Summerlin West Village 22-Kettle Ridge Drive
(Sheet J)

CITY OF LAS VEGAS INTER-OFFICE MEMORANDUM			DATE: January 21, 2021
TO: Land Development Services Department of Building & Safety			FROM: Albert Sung, P.E. Flood Control Project Engineer Department of Public Works
SUBJECT: Drainage Study for: Summerlin West Village 22 - Kettle Ridge Drive (Street J) (from Sunset Run Drive to Kindle Rise Way)			COPIES TO: Atkins Global
Cross Streets:	Kettle Ridge Drive and Sunset Run Drive		Howard Hughes Company, LLC.
File Number:	F:\Depot\DSMemos\DS5349C.doc		Bart Anderson, P.E., DevCo
Parcel Number:	137-23-210-001		CCRFC
Zoning Action:	N/A		
FEMA Flood Zone	YES	NO X	
Proposed Storm Drain	YES X	NO

Supplement to Addendum #1

RE: Supplement to Addendum 1 to the Technical Drainage Study for Summerlin West Village 22 Kettle Ridge Drive: Sunset Run Drive to Kindle Rise Way

DESIGNED BY: N. BARCOS
DRAWN BY: L. MAMACLAY
CHECKED BY: P. BATES
HORIZ.: NONE
VERT.: NONE
JOB NO. 1000066768
DATE: NOVEMBER, 2020
DRAWING NO. 21/29
CLV 00-000000

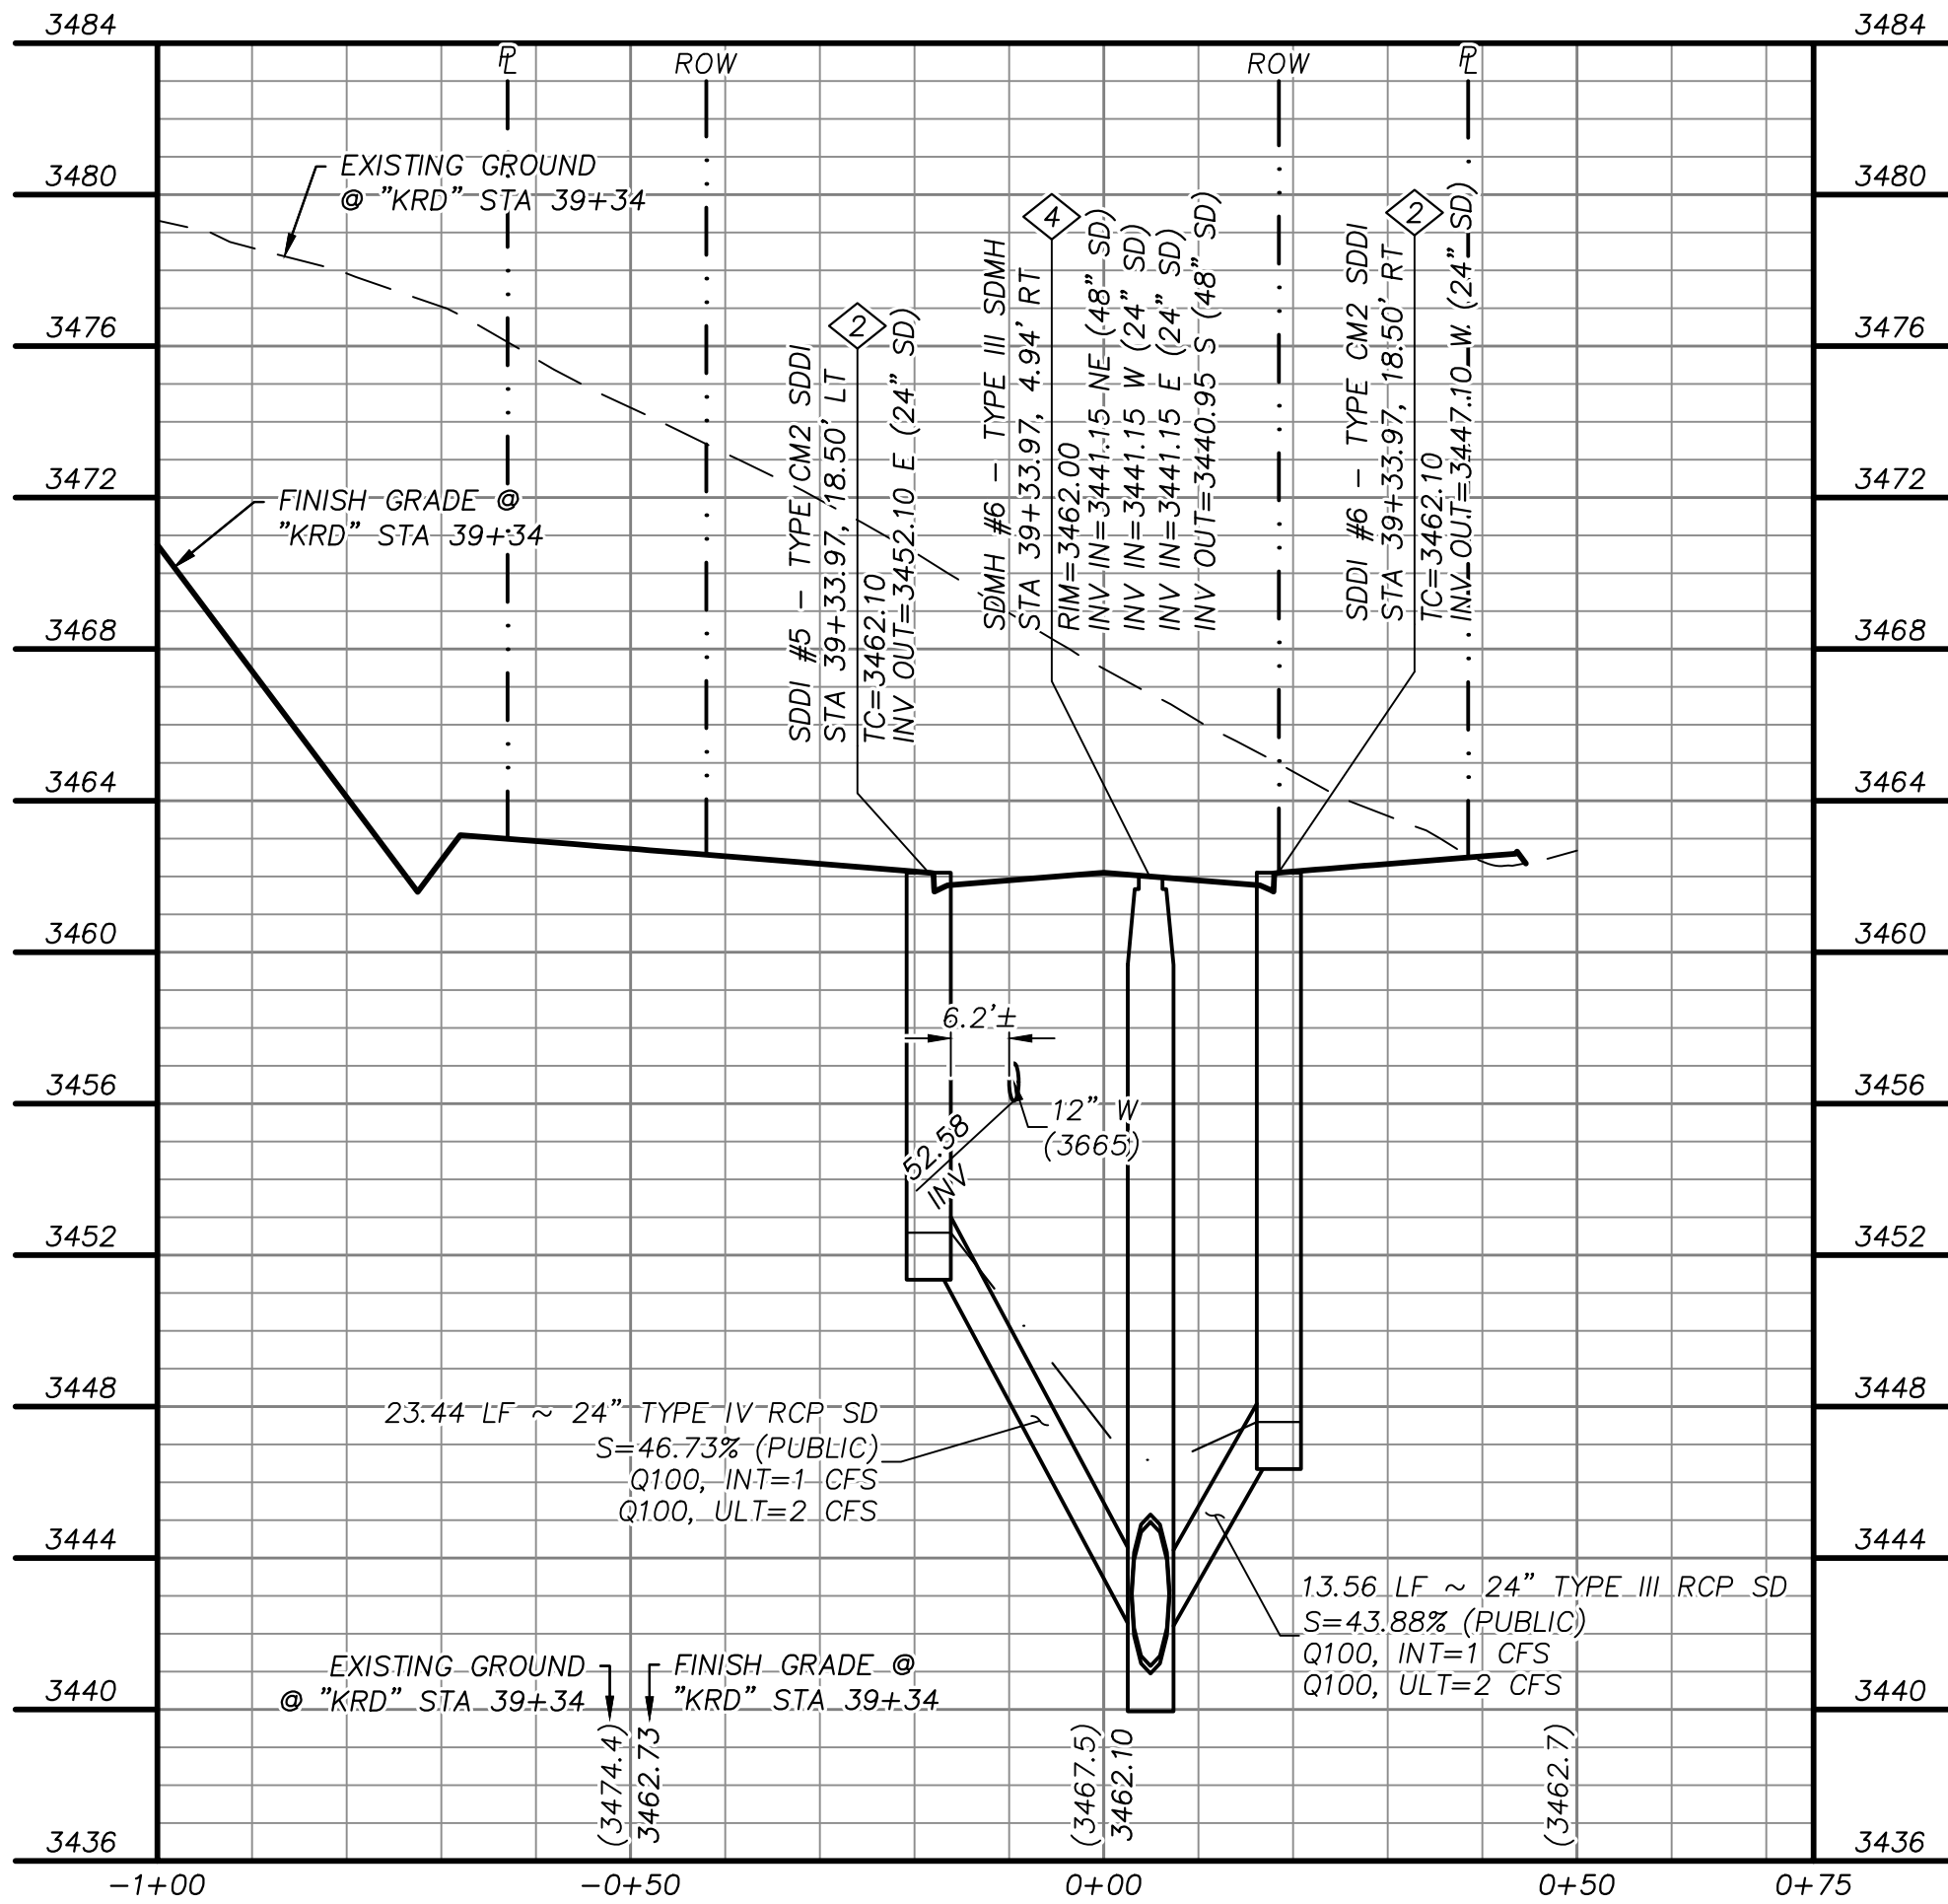
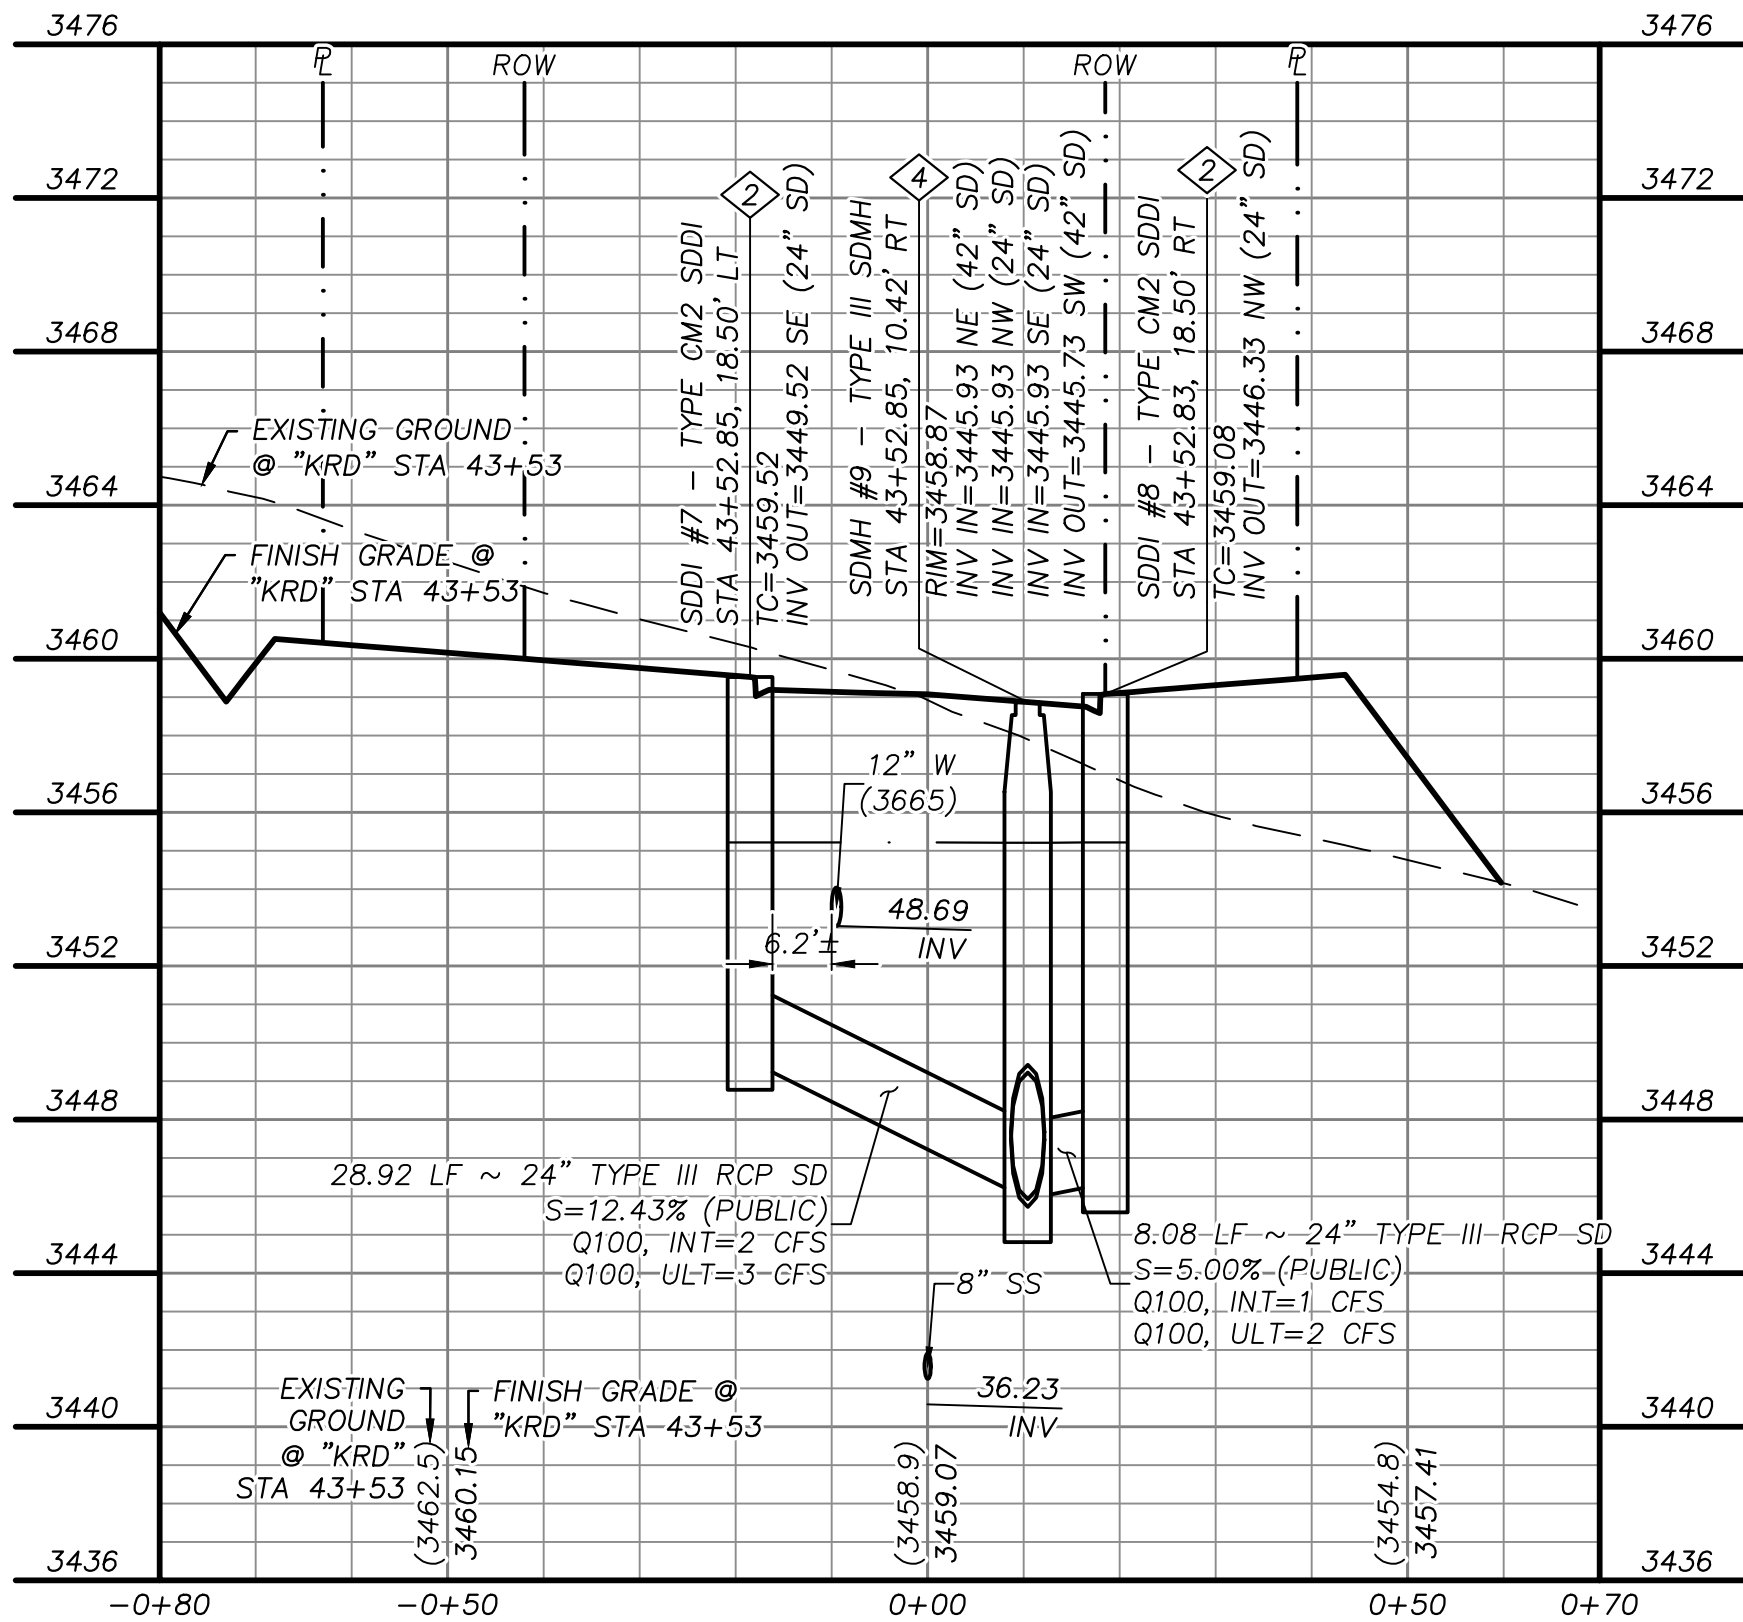
Comment #6: Previous Comment: Sheet 20/26 & Sheet 21/26: In general, the HGL shown on the profiles for the laterals do not match the calculations. For example: The HGL is lower than the base of the inlet for SDDI #10.

6. **Previous Comment: Sheet 20/26 & Sheet 21/26: In general, the HGL shown on the profiles for the laterals do not match the calculations. For example: SDDI #2: Calculation shows a lower water surface while the profile shows a much higher water surface. SDDI #5: The HGL is even lower than the base of the inlet. Same for SDDI #10.**

The response to SDDI #10 is still un-satisfactory: The HGL is still lower than the base of the inlet. Perform better quality control in the next submittal.

Comment response: SDDI #10 lateral has been revised to show the correct HGL. The associated WSPG-W output is included for review convenience.
